COUNCIL ASSESSMENT PANEL MEETING

AGENDA – 8.3

Applicant: Woodforde JV Stage 3A Pty Ltd	Landowner: Woodforde JV Stage 3A Pty Ltd
Agent: Future Urban	Originating Officer: Doug Samardzija
Development Application:	21/327/473
Application Description: Five storey residential flat building comprising of 57 dwellings, associated car parking, swimming pool & associated safety barriers, fencing (maximum height 2m), landscaping, associated communal facilities & associated earthworks	
Subject Land: Pces:6031-3 Sec: P626 DP:122699 CT:6232/338 (now new Lot 228)	General Location: Buchanan Drive., Kintyre Road and MacIntosh Crescent, Woodforde Attachment – Locality Plan
Development Plan Consolidated : 08 August 2019 Maps AdHi/1, AdHi/11 & AdHi/96	Zone/Policy Area: Residential Zone - Glen Stuart Policy Area
Form of Development: Merit	Site Area: 3108m ²
Public Notice Category: Category 3 Notice published in The Advertiser on 11 June 2021	Representations Received: 2 Representations to be Heard: 0

VIEW 6 - Camera RL 162.69

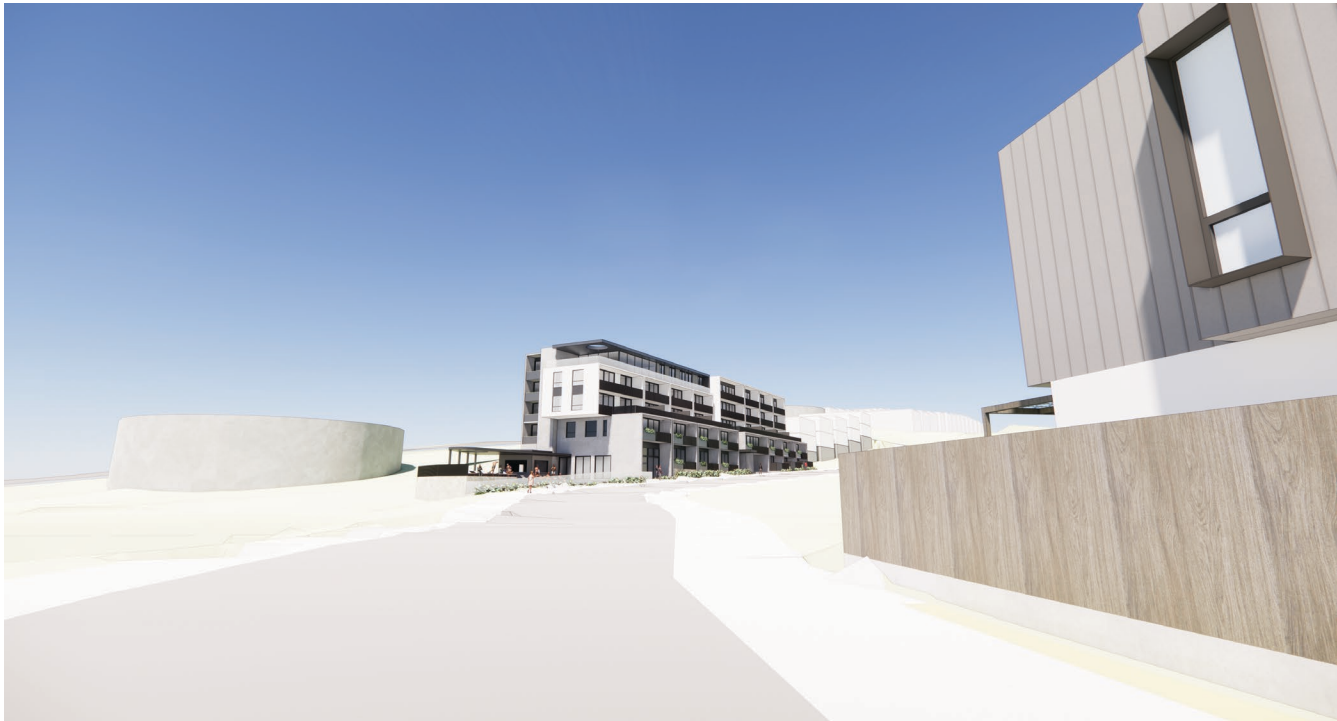
19. 'View 6' in the bottom left-hand corner of Drawing A7.03[A1] and the perspective on the right-hand side of Drawing A7.11[A1] show the scale relationship between the existing and proposed five-storey buildings within the confines of Hamilton Hill.

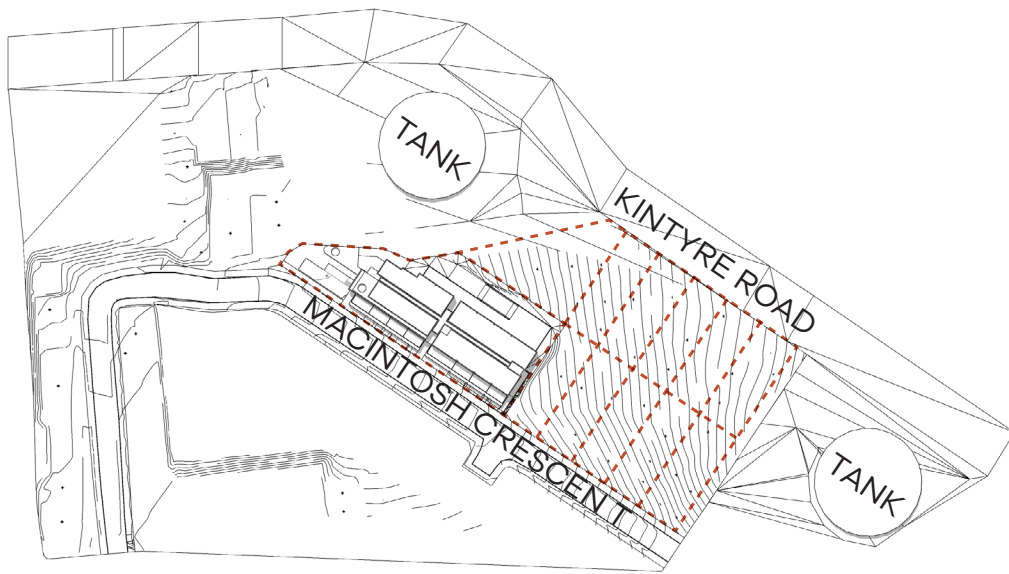
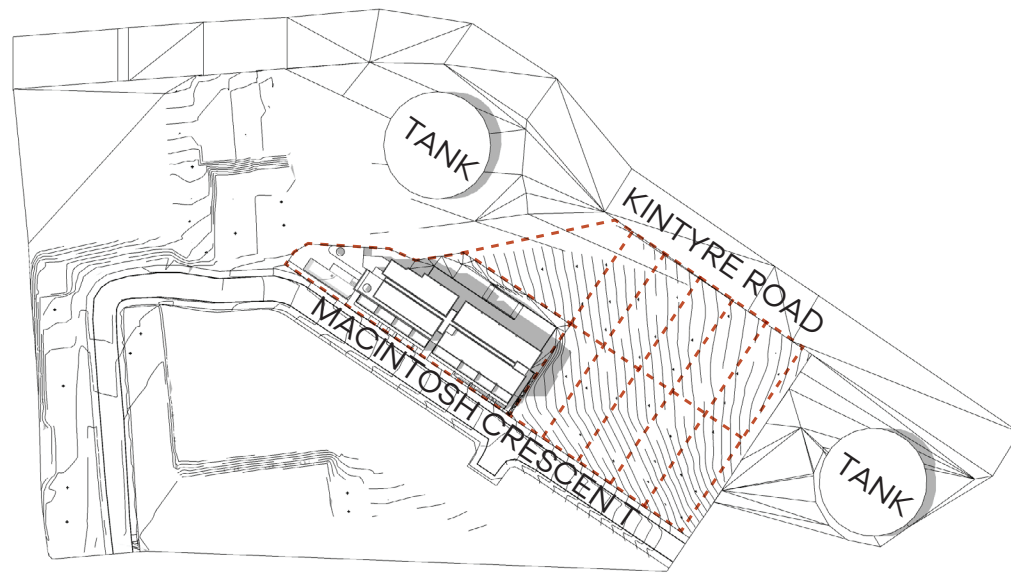
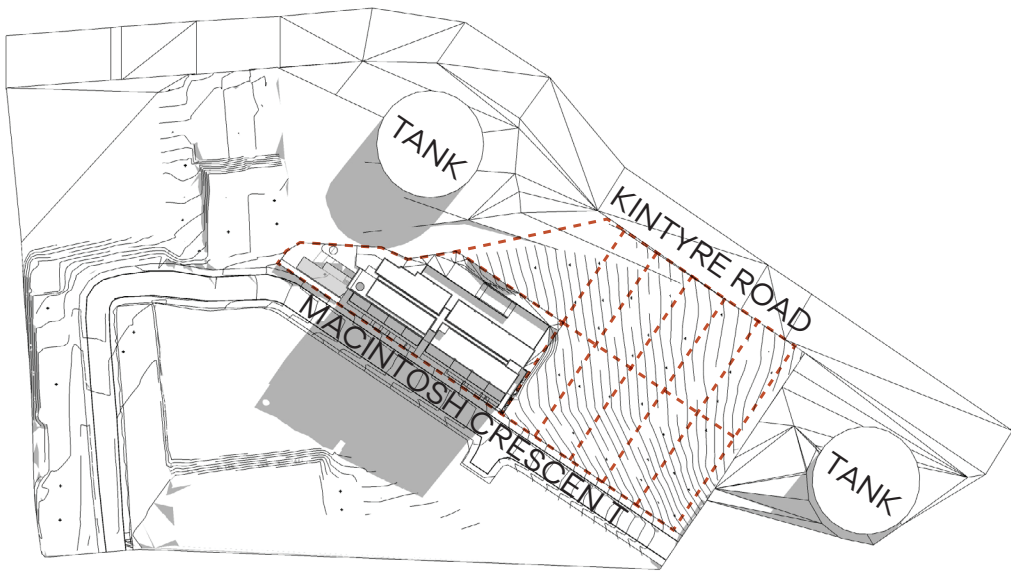
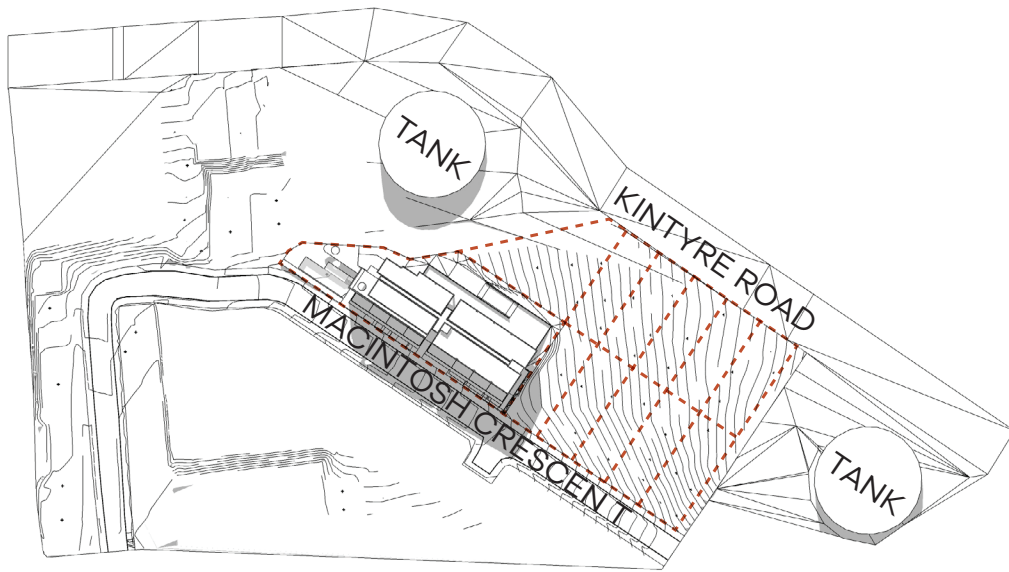
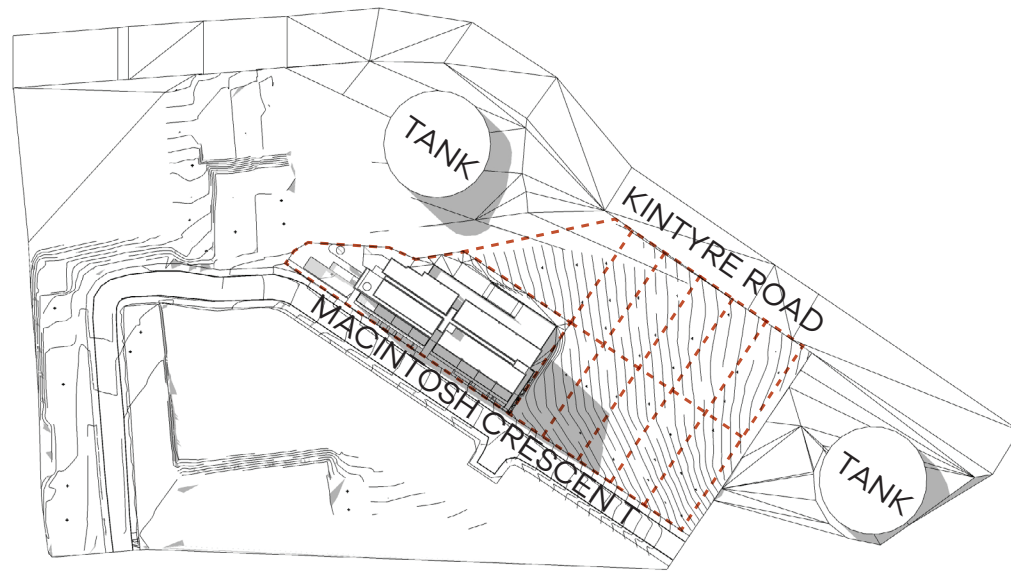
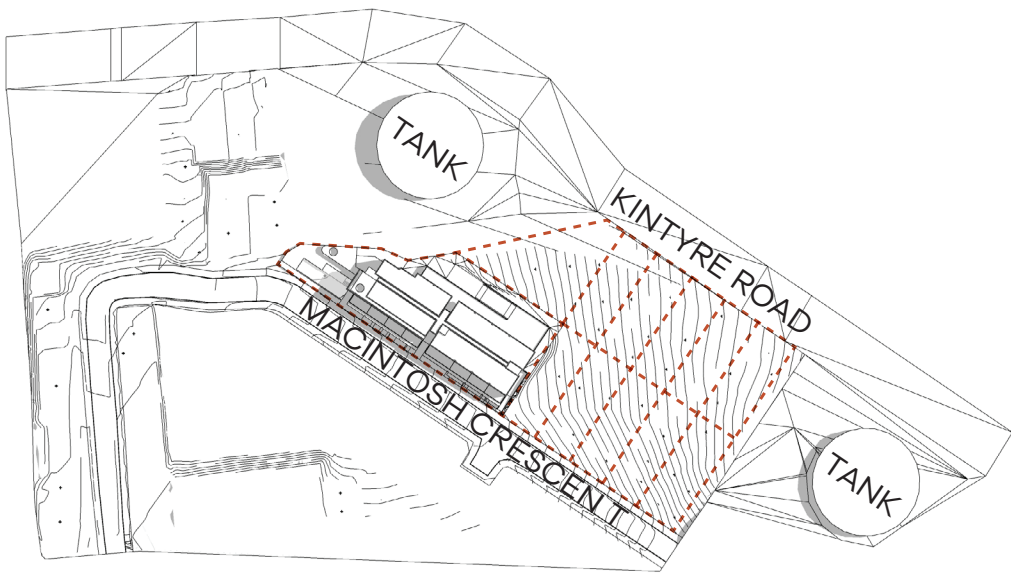
The shadow diagrams provided illustrate that the future allotment 237 immediately to the east of the subject land will be overshadowed between the hours of 12pm and 3pm during the winter solstice. The plan shows that the private open space of this allotment will continue to receive access to sunlight for at least 6 hours of the day. There will however be impacts on any potential future solar panels that might be positioned on the dwelling being that it is located south of the residential flat building and will be overshadowed for at least 3 hours during the winter solstice.

6. The shadow diagrams have been updated and now show the residential allotments on the north-eastern and south-eastern sides of the site. It is clear from these diagrams that the proposed building will not overshadow Allotments 240 to 247, and that the rear half or thereabouts of Allotments 237 to 239 will continue to receive access to sunlight for six consecutive hours (between 9:00 am and 3:00 pm) on the winter solstice. This is where the private open spaces are likely to be situated.

Figure 2: Turn path review for Ground Level

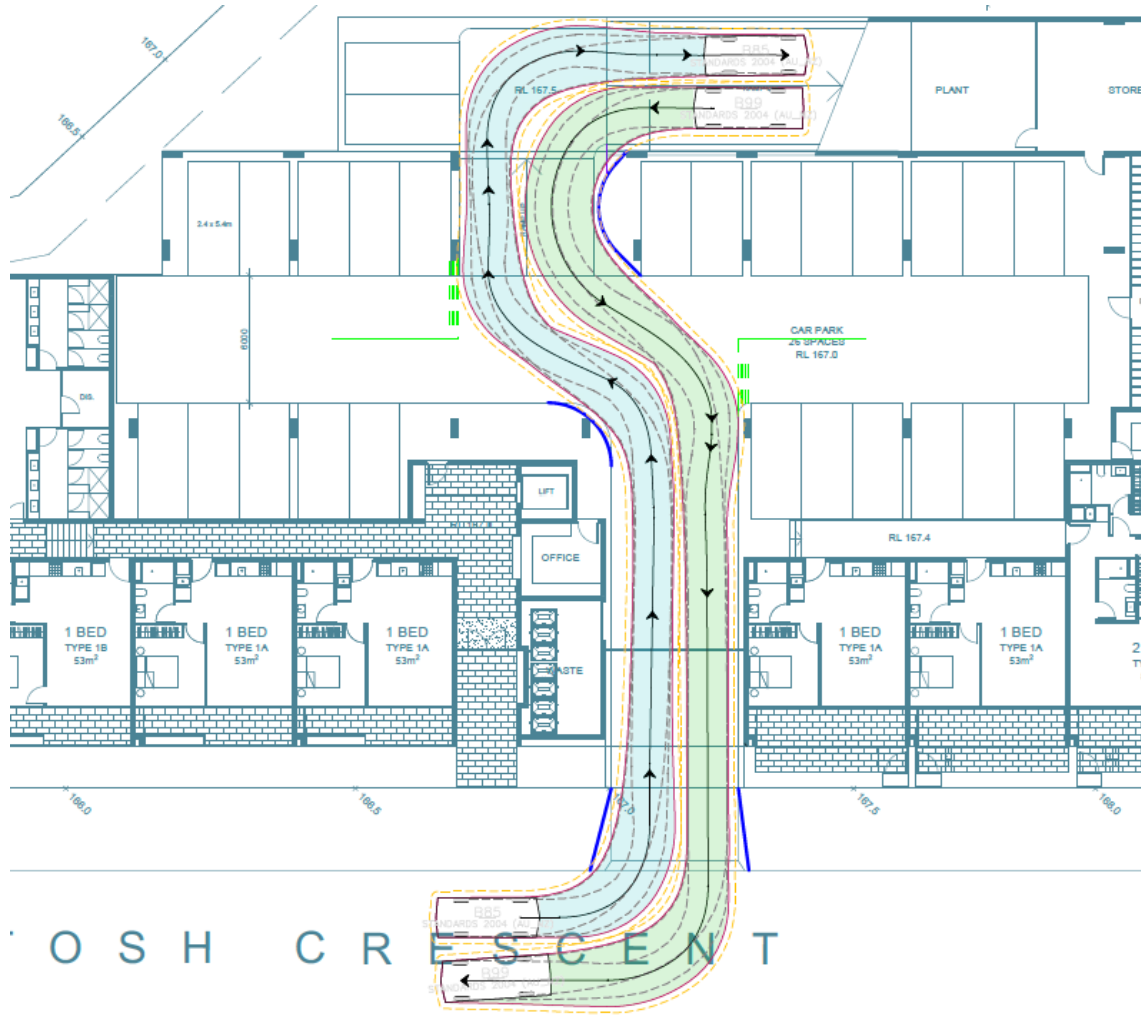
Turn paths for entry and exit movements at key locations have been reviewed in accordance with the Standard. These are shown in Figure 2 and Figure 3.

These figures indicate minor amendments to kerb alignments to meet the turn path requirements through the car park across ground and level 1, and also give-way controls required on the ground level. These amendments are not significant and can be included in the detailed design.
